**FINAL**  
**MONITORING REPORT**  
**2019 (Year 1)**

**HERON STREAM AND WETLAND MITIGATION SITE**  
Alamance County, North Carolina

Subject: Heron – Year 1 (2019) Monitoring Report  
Cape Fear 02 River Basin, Contract 007192, Alamance County, DMS Project No. 100014

Below is the response from Restoration Systems to all comments received from DMS regarding the Year 1, 2019, Heron Monitoring Report. DMS comments are in black, and our responses are in blue. Please do not hesitate to reach out if you would like to discuss.

<b>Site</b>	Heron
<b>Watershed:</b>	Cape Fear, 0303002
<b>XS ID</b>	UT 1, XS - 1, Pool
<b>Feature</b>	Pool
<b>Date:</b>	8/13/2019
<b>Field Crew:</b>	Perkinson, Radecki

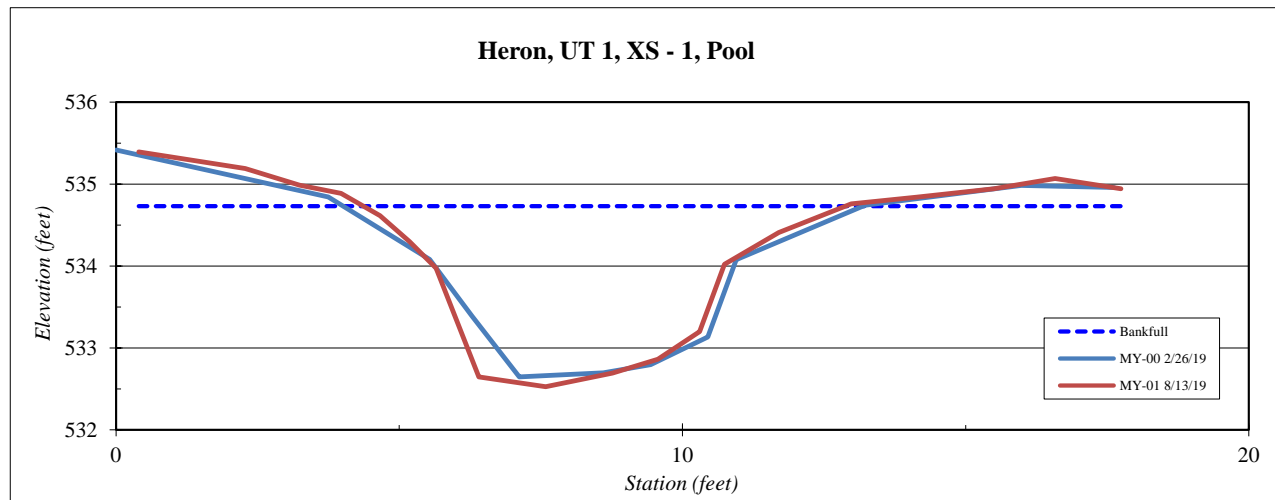
2. Morphology – Check BHR calcs between the overlays and the summary tables. They do not seem to be matching in comes cases (e.g. XS 2).

Several of the calculations in the cross-section overlays were incorrect. Those have been corrected, and the overlays now match the tables.
